Application Note TNT 32 Series Substituts

- Replacement for TNT 32 Series
 - ⇒ TNT 32 (restart lock)
 - ⇒ TNT 32/R (no restart lock)

Find the correct replacement

Wiring overview

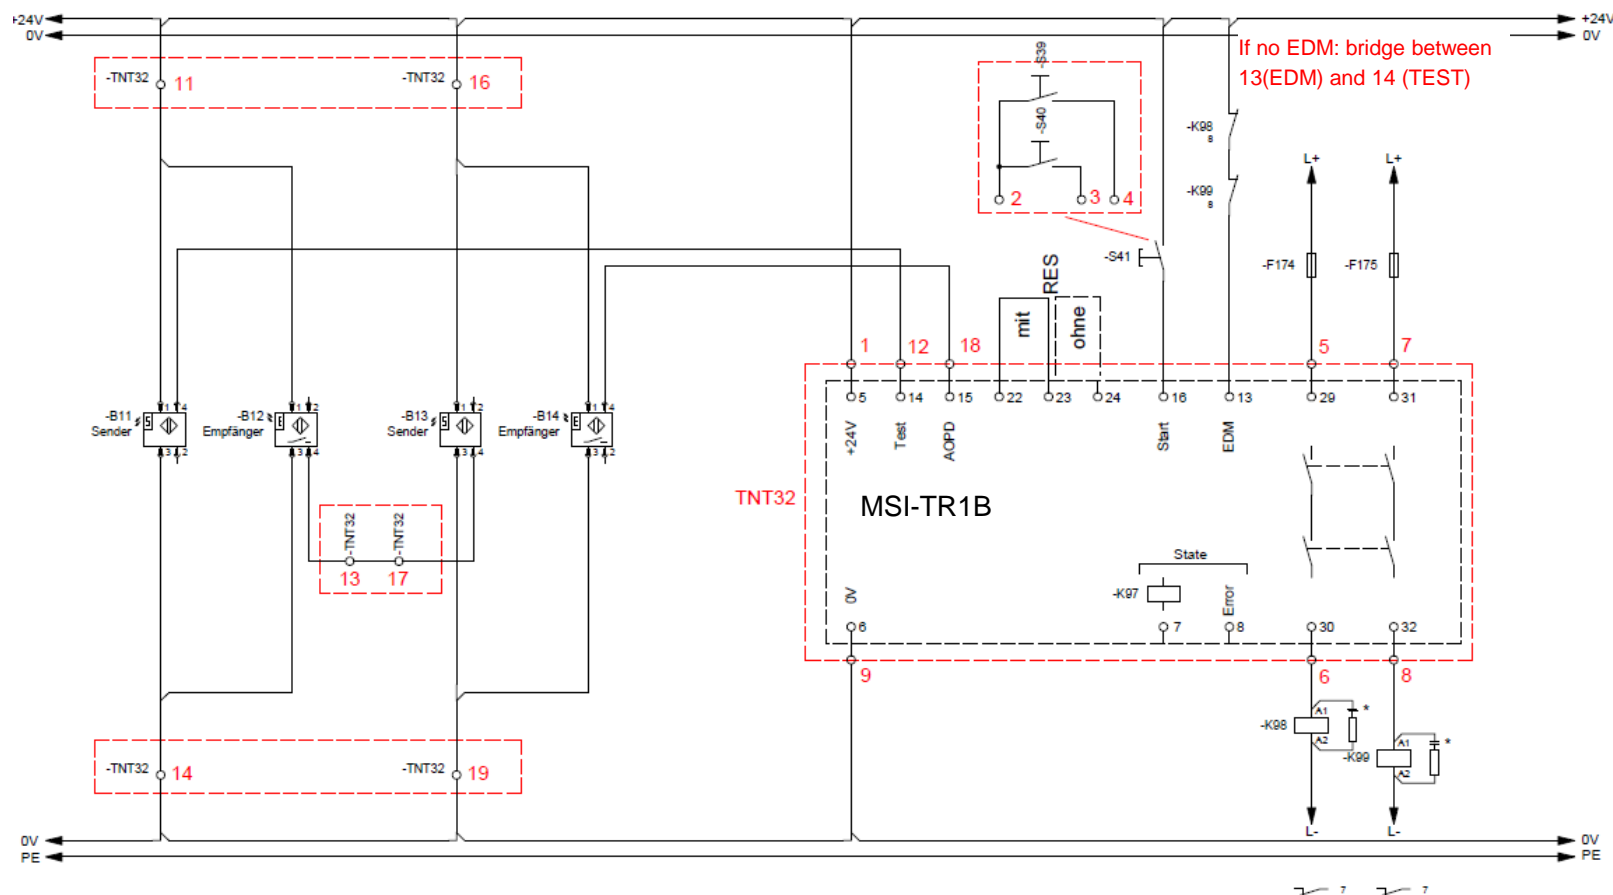
- For an exchange of a TNT 32 in an existing machine, a TR1B-0x system is sufficient. The units are technical equal. The reduced performance level from PL-d to PL-c systems from the change of the standard EN / IEC 61496-1. This change is not a major change (EU 2009/104/EG)
- The replacement is not possible with TLS85/4 and TLS72/4 series.
